Informal document **GRSP-56-20**
(56th GRSP, 9-12 December 2014,
agenda item 16)

Clarification of Relaxation Area(s) for Flexible lower legform to bumper test

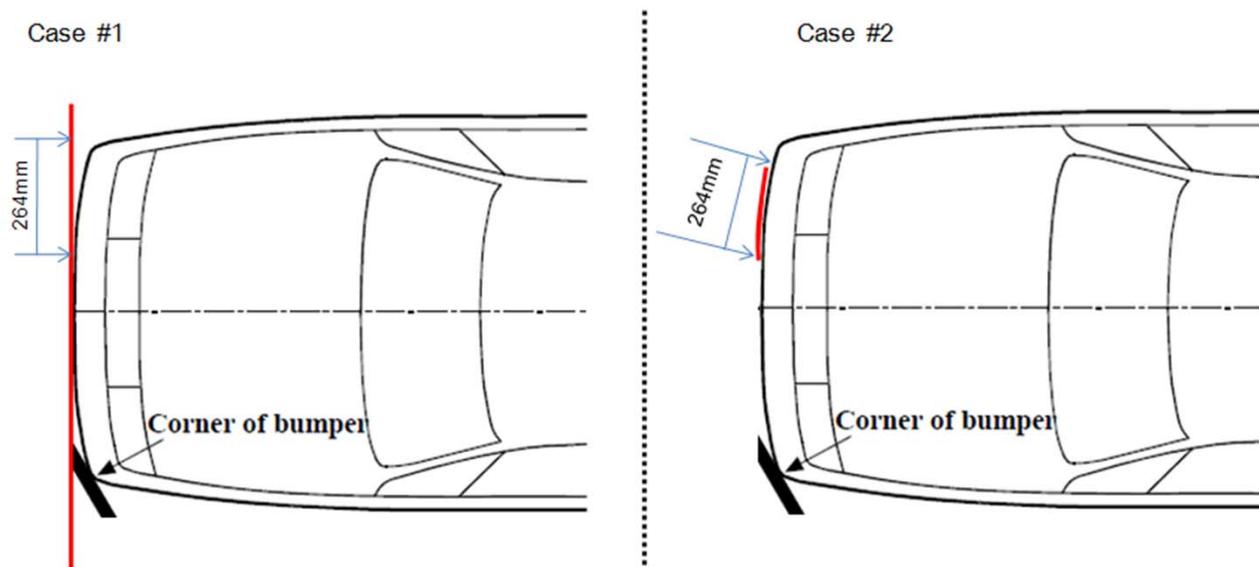
Definition of width of 264 mm is not clear in measurements

- a) It can be measured horizontally
- b) or along the bumper line

It is not clear enough the measurements of injury criteria relaxation area widths whether the length is a distance in a straight line of the bumper (Case #1) or contour line of the bumper (Case #2).
